United States Environmental Protection Agency Region IX (EPA)

9/24/2012

Please consider these ACME comments on the Draft Final Technical Memorandum Deep Borehole Soil Sample Results, AREA IV Radiological Study, Santa Susana Field Laboratory (SSFL), Ventura County, California – EPA Contract Number: EP-S7-05-05-Task Order No. 0038 Prepared for EPA by Hydrogeologic, Inc. September 7 of 2012.

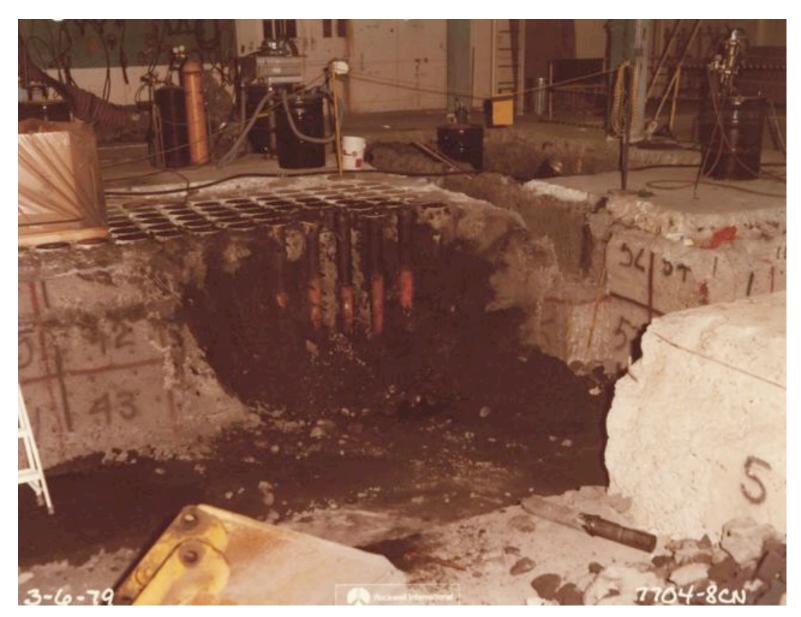
In the case of Building 4073 (Above Photo), this building was demolished down to the lower underground level and then backfilled with the rubble. Now that it is known and documented in the EPA Historical Site Assessment, the rubble should be removed and then Deep Borehole Sampling should be conducted in these trenches.
